**LOST CREEK ISR, LLC**

**Re: Response to NRC RAIs 20-26 on LC East and KM Amendments  
Lost Creek ISR Project License SUA-1598: Docket 040-09068**

**Request for Additional Information  
Lost Creek KM Horizon and Lost Creek East Amendment Application  
RAIs 20-26**

**FIGURE 2.7-10.5**  
**UKM Potentiometric Surface, 12/08/08**  
**Contour Interval = 10 Feet (amsl)**

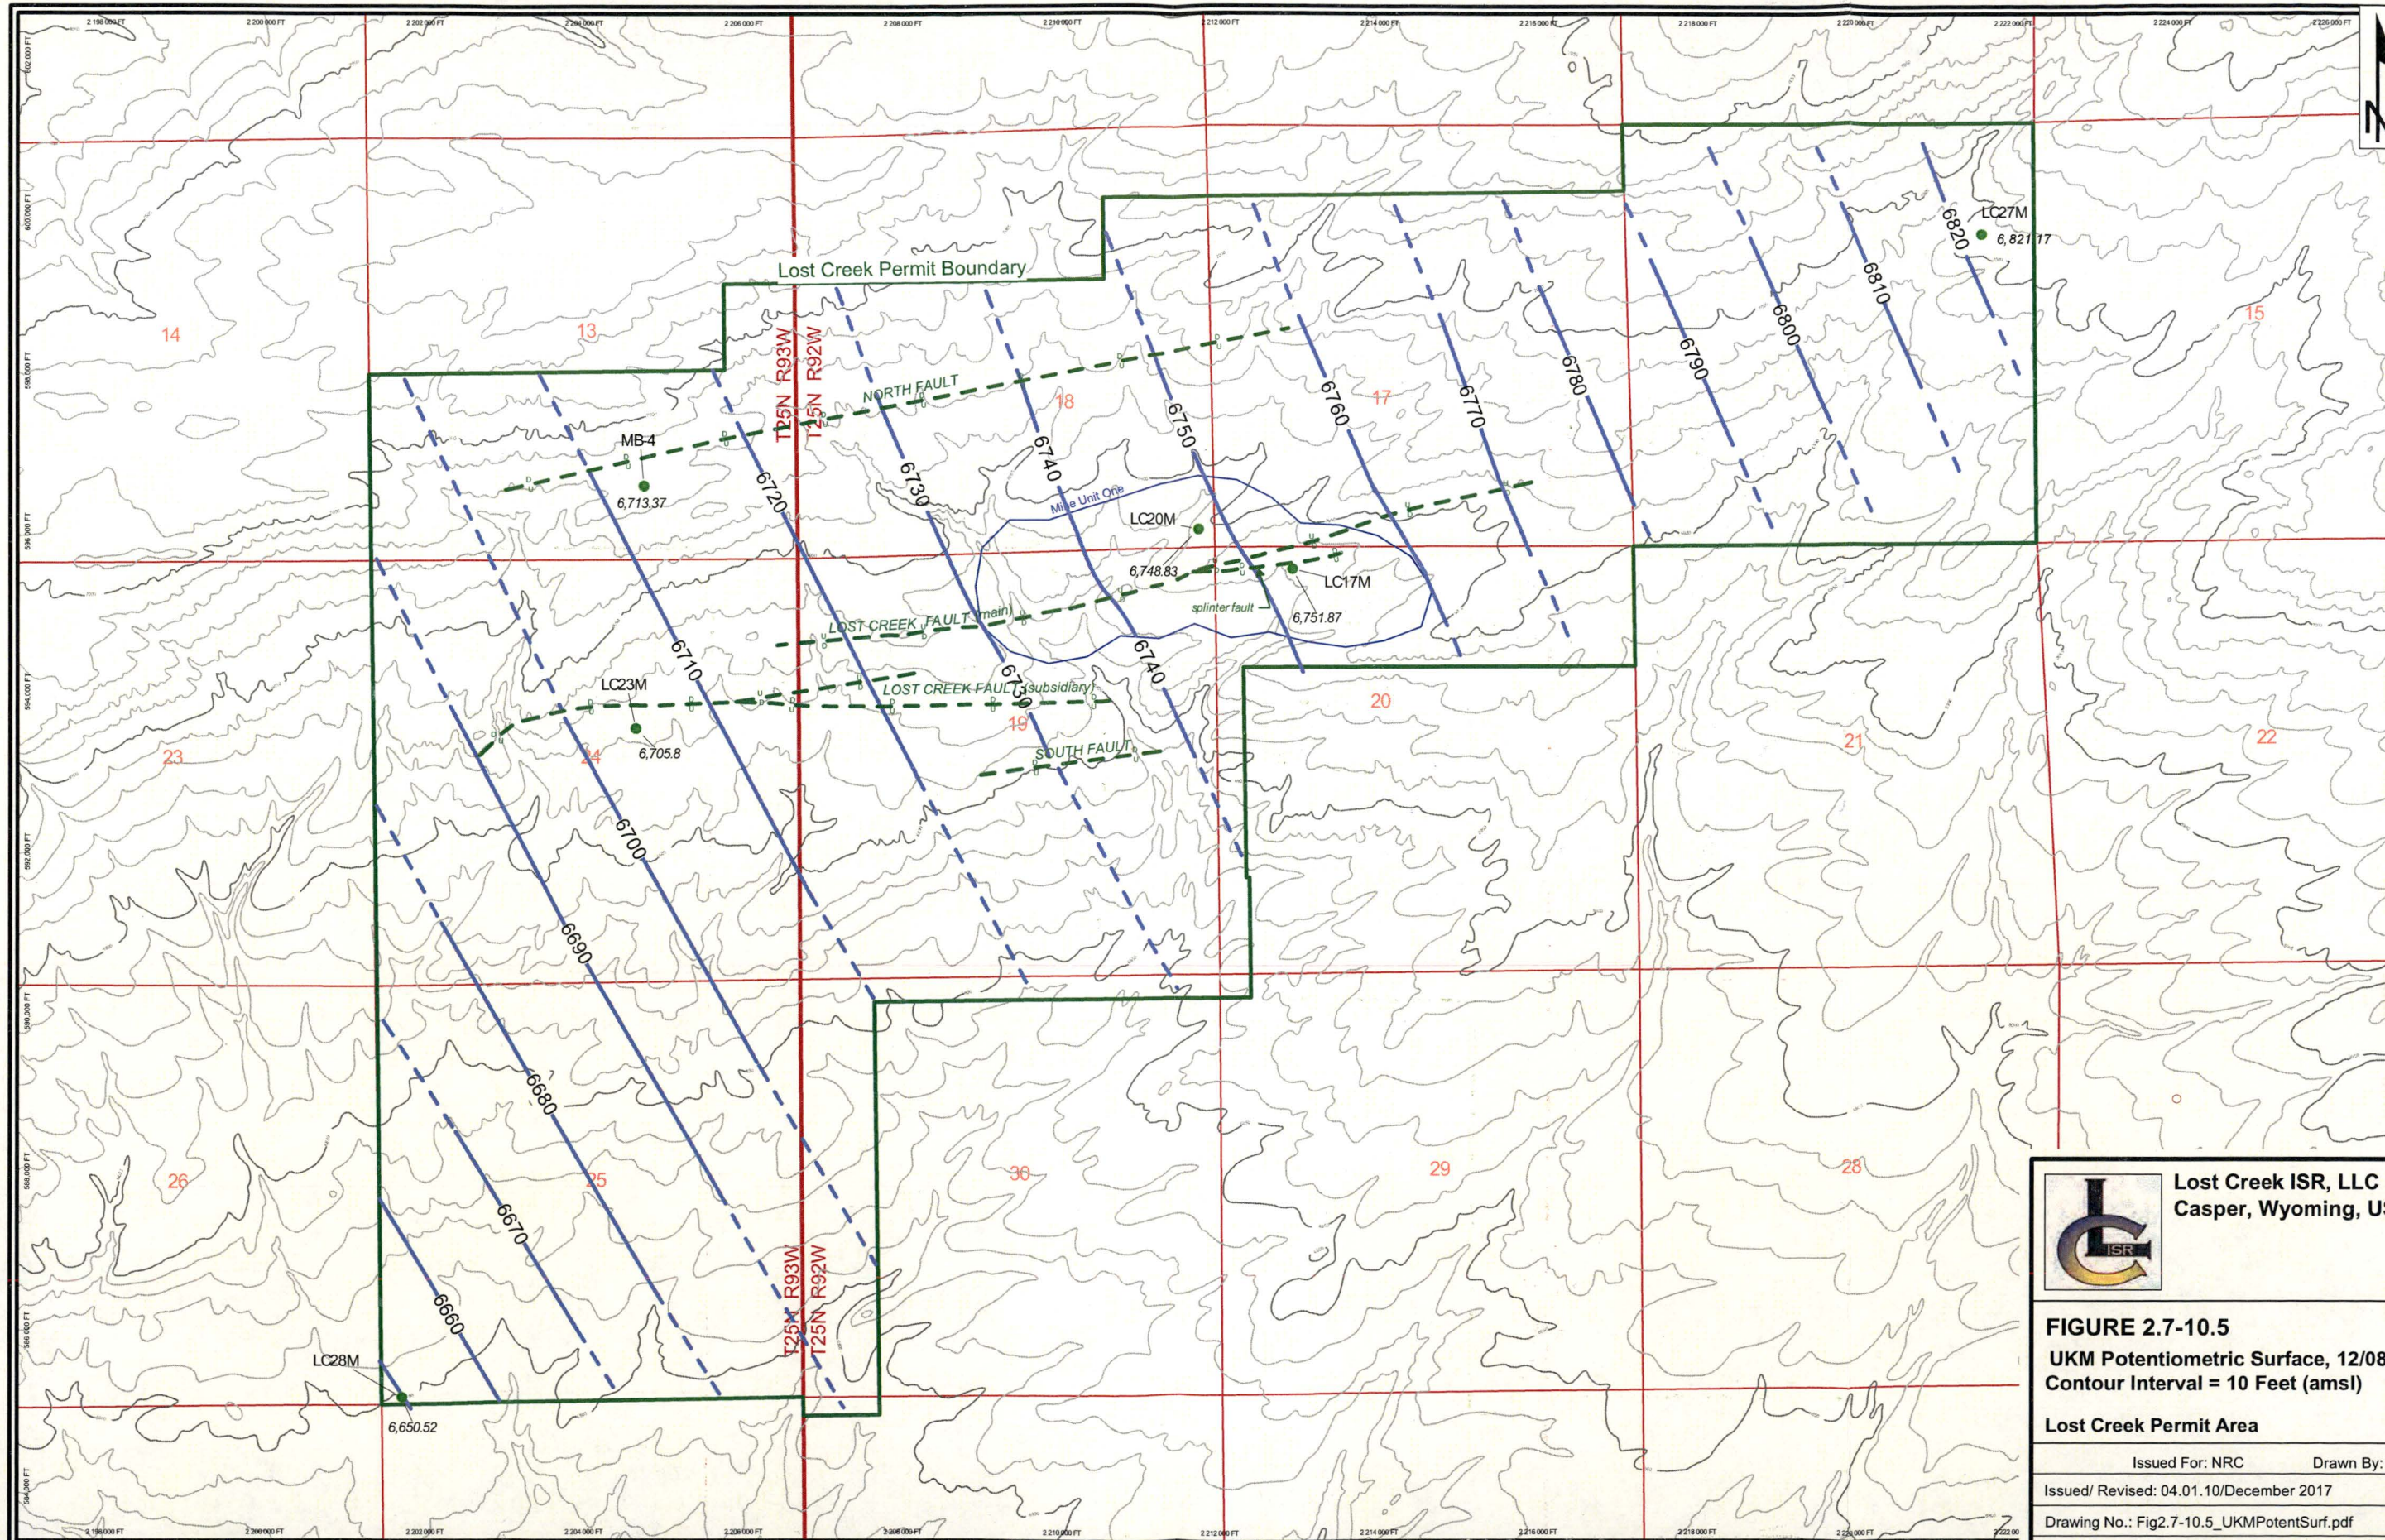
Table 2.7-6 of the LMA lists well M-N3 as an "N" completion horizon. Table 2.7-6 lists the water elevation at this well at 6765.83 feet above mean sea level (ft-amsl) on February 8, 2012 and 6711.33 on March 10, 2014. The KMA lists the depth to water at this well below 6711.33 for measurements between November 5, 2013 and March 10, 2014 though most measurements were taken in one month (November 2013) (page 246 of 576 of ADAMS Volume 4). In addition water levels at well LC27M appear higher than in the past (6820.9 ft-amsl in 2014(?) versus 6796.23 ft-amsl in 2008). Consistent with that expected for confined conditions without any induced stresses, the fluctuations at most other wells are less than a few feet.

- a) Please correct the narrative and tables as to the finding of whether well M-N3 is an "M", "M/N" or "N" well. If well M-N3 is an "M" well, then the text, tables and figures need to be revised accordingly.
- b) Please provide a historic summary of water fluctuations at all wells and LCI's explanation for any abnormal behavior.

The groundwater elevation in 2008 for LC27M was an apparent error based on an incorrect measuring point elevation as revealed by more recent survey data and the contour interval on the map. Only LC27M was affected and the groundwater elevation has been corrected. However, the correction of the groundwater elevation has also affected the groundwater elevation contouring on Figure 2.7-10.5 which was corrected and a replacement provided. With the corrections made to the table, therefore, there are no significant fluctuations (i.e. on the order of approximately 10 to 20 feet) in water levels of note.

KPW-1A Theis Drawdown

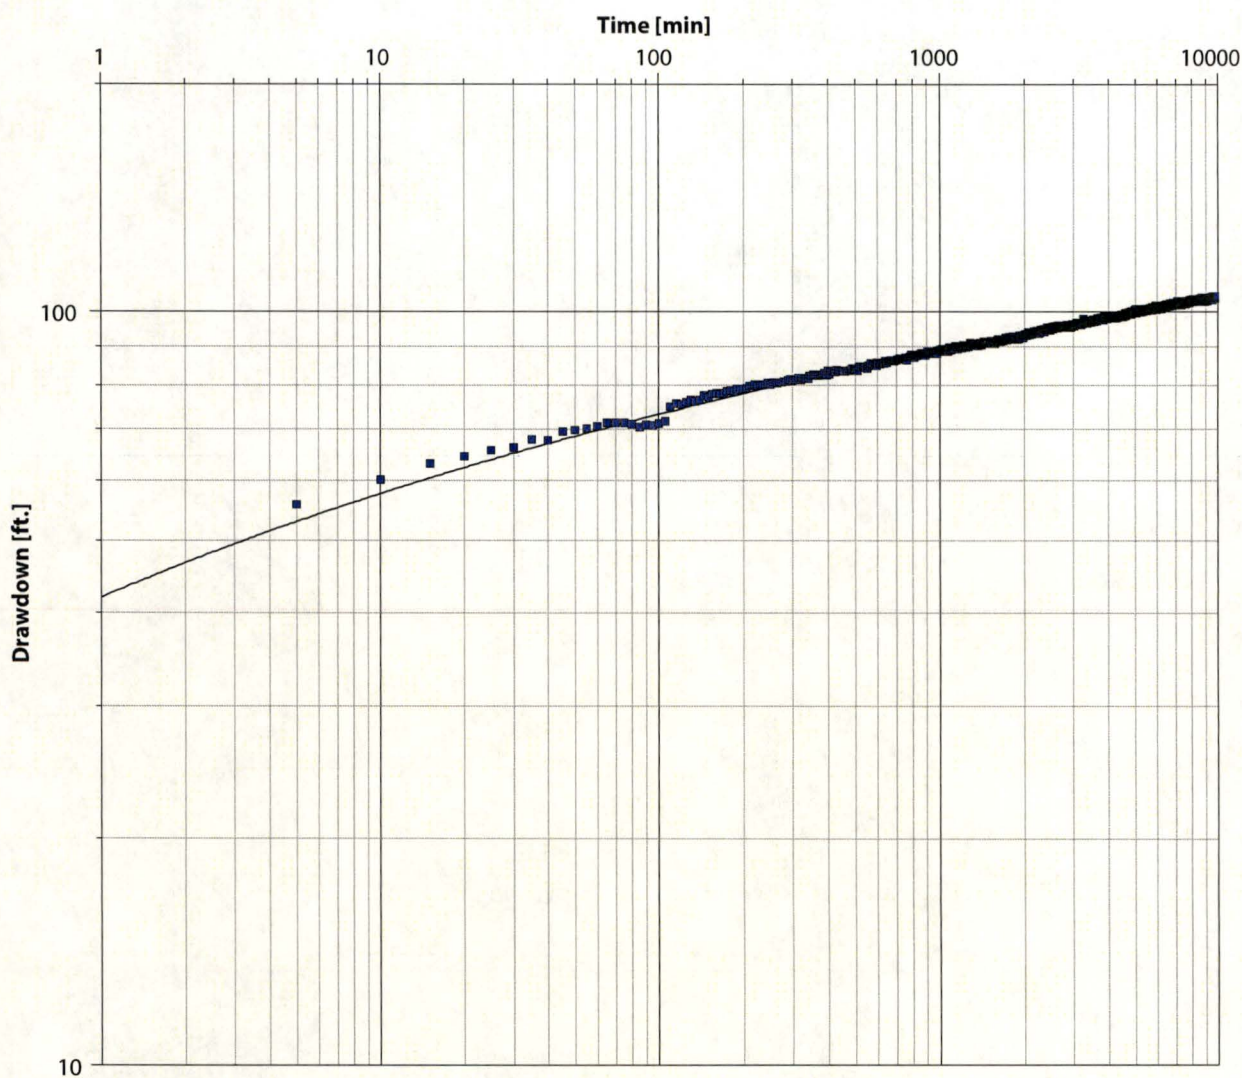
KM Amendment Volume 1, electronic Attachment 2.7-2, contains a pdf of LOST CREEK HYDROLOGIC TEST COMPOSITE KLM HORIZON PUMP TESTS KPW-2 AND KPW-1A JUNE-JULY 2009. The Theis curve fitting plot for KPW-1A (pdf page 87 of 97) indicates a KM aquifer thickness of 90 feet. This thickness is used to calculate the hydraulic conductivity of the tested formation. On the other hand, Table 7-2, and other curve fitting plots, within this report indicates that the analyses were based on a KM thickness of 115 feet.

Please resolve this discrepancy throughout the attachment and main body of the application as necessary.

Petrotek was consulted and the entry of 90 ft on the aquifer thickness for KPW-01A on the Theis curve (pdf page 87 of 97) was found to be in error as well as the hydrologic conductivity value for KPW-1A on Table 7-2. The errors were corrected and the replacement pages provided. The error did not affect the conclusions of the report.
